**STAFF REPORT**  
**(One-Step Final Plat)**

**CASE NUMBER:** S/D 99-55 - PRAIRIE CROSSROADS UNITED METHODIST CHURCH ADDITION

**STAFF REPORT**  
(One-Step Final Plat, Deferred 8/19/99)

**CASE NUMBER:** S/D 99-55 - PRAIRIE CROSSROADS UNITED METHODIST CHURCH ADDITION

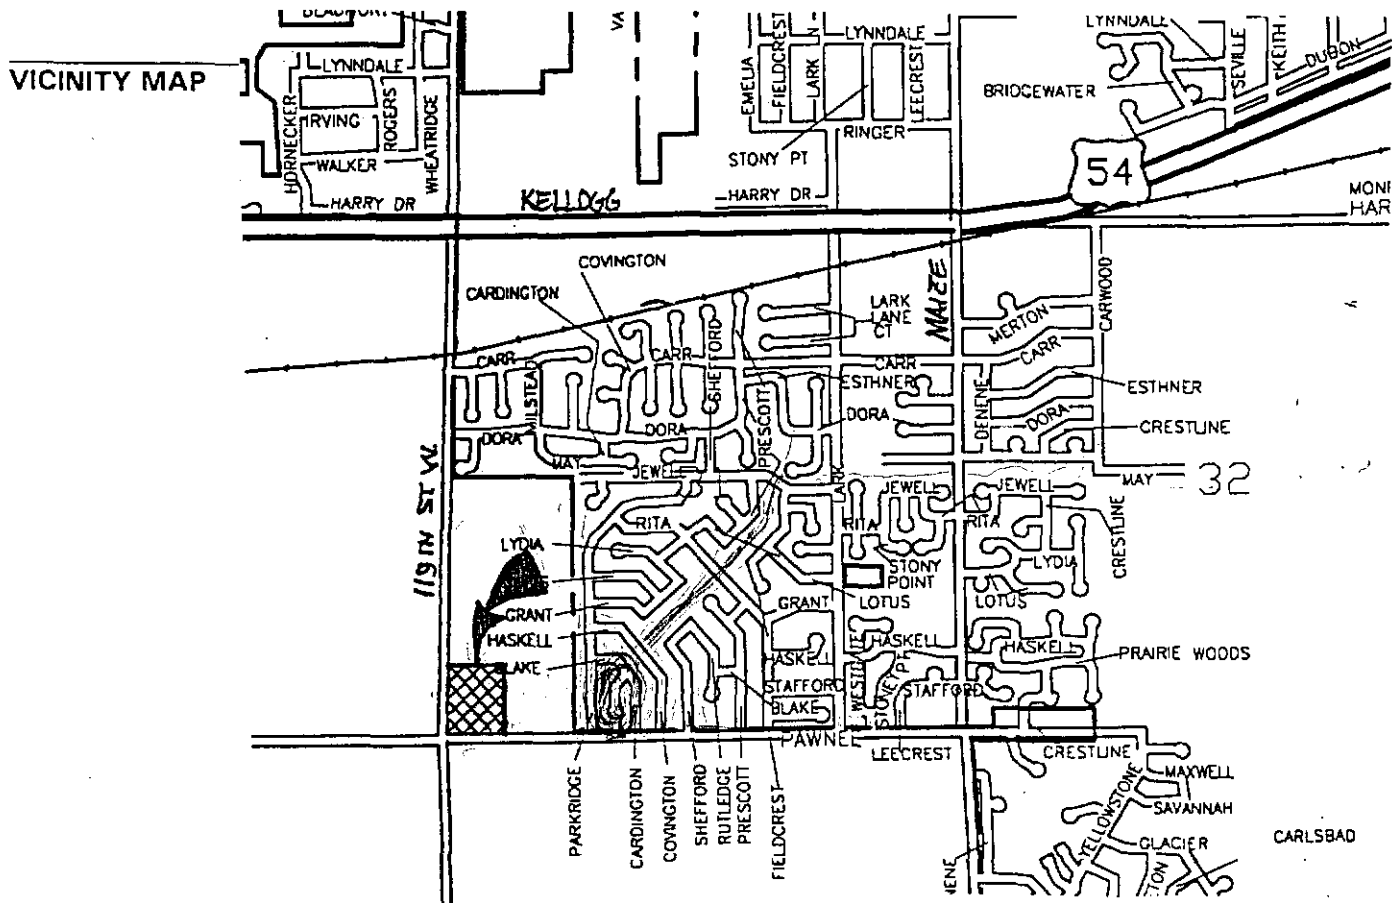
- A. Since neither municipal water nor sanitary sewer is available to serve this property, the applicant shall contact the Environmental Health Division of the Health Department to find out what tests may be necessary and what standards are to be met for approval of on-site sewerage facilities and water wells. A memorandum shall be obtained specifying approval.

- B. City Engineering needs to indicate if petitions for future extensions of municipal water and sanitary sewer need to be provided at this time.
- C. If improvements are guaranteed by petition, a notarized certificate listing the petitions shall be submitted to the Planning department for recording.

- D. County Engineering needs to comment on the status of the applicant's drainage plan.
- E. County Engineering needs to comment on the access controls. The plat proposes one access opening along 119<sup>th</sup> St. West and one access opening along Pawnee.

- F. County Engineering needs to comment on the need for any traffic improvements to perimeter streets,
- G. Documentation must be provided that the pipeline easement as indicated on the platting binder has been released. If the easement has been confined, proof needs to be provided that it does not in any way encroach this site. If the easement does impact this site, it shall be shown and subject to the standard pipeline conditions.

- H. The platting binder indicates that the site's ownership is in the party of "Wichita United Methodist District Union". This name must also appear on the owner's signature block on the final plat tracing.

- I. The plattor's text shall include language ~~that~~ a drainage plan has been developed for the plat and that all drainage easements, rights-of-way, or reserves shall remain at established grades or as modified with the approval of the applicable City or County Engineer, and unobstructed to allow for the conveyance of stormwater.

- J. The applicant shall install or guarantee the installation of all utilities and facilities which are applicable and described in Article 8 of the MAPC Subdivision Regulations. (Water service and fire hydrants required by Article 8 for fire protection shall be as per the direction and approval of the Chief of the Fire Department.)

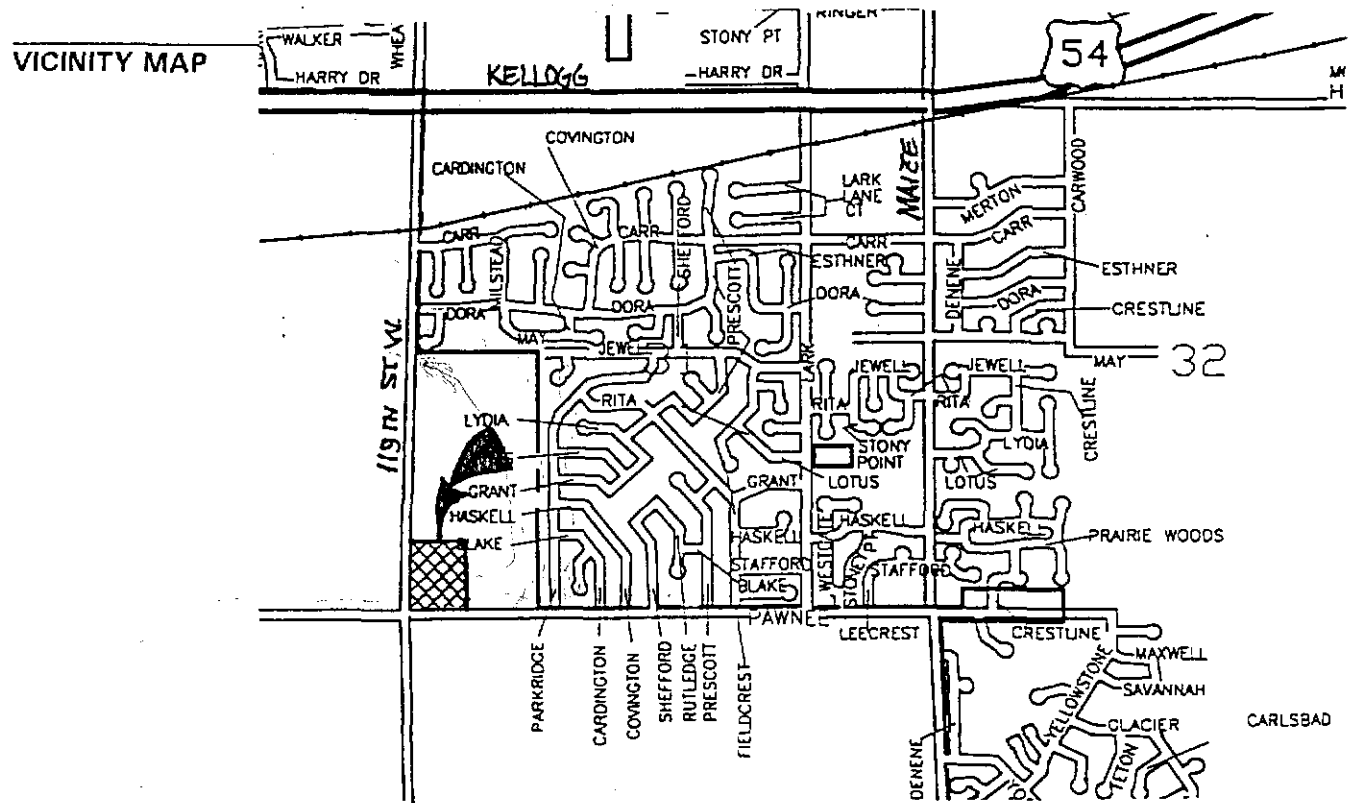
- A. Since neither municipal water nor sanitary sewer is available to serve this property, the applicant shall contact the Environmental Health Division of the Health Department to find out what tests may be necessary and what standards are to be met for approval of on-site sewerage facilities and water wells. A memorandum shall be obtained specifying approval. Health Department recommends connection to City sewer.

- B. City Engineering needs to indicate if petitions for future extensions of municipal water and sanitary sewer need to be provided at this time. City Engineering has requested petitions for extension of City sewer and a petition for future City water.

- D. County Engineering needs to comment on the status of the applicant's drainage plan. A drainage plan has not been approved.
- E. County Engineering needs to comment on the access controls. The plat proposes one access opening along 119<sup>th</sup> St. West and one access opening along Pawnee. The access controls are acceptable.

- F. County Engineering needs to comment on the need for any traffic improvements to perimeter streets, No improvements are required for perimeter streets.

- G. Documentation must be provided that the pipeline easement as indicated on the platting binder has been released. If the easement has been confined, proof needs to be provided that it does not in any way encroach this site. If the easement does impact this site, it shall be shown and subject to the standard pipeline conditions.

- H. The platting binder indicates that the site's ownership is in the party of "Wichita United Methodist District Union". This name must also appear on the owner's signature block on the final plat tracing.

- I. The platting text shall include language that a drainage plan has been developed for the plat and that all drainage easements, rights-of-way, or reserves shall remain at established grades or as modified with the approval of the applicable City or County Engineer, and unobstructed to allow for the conveyance of stormwater.
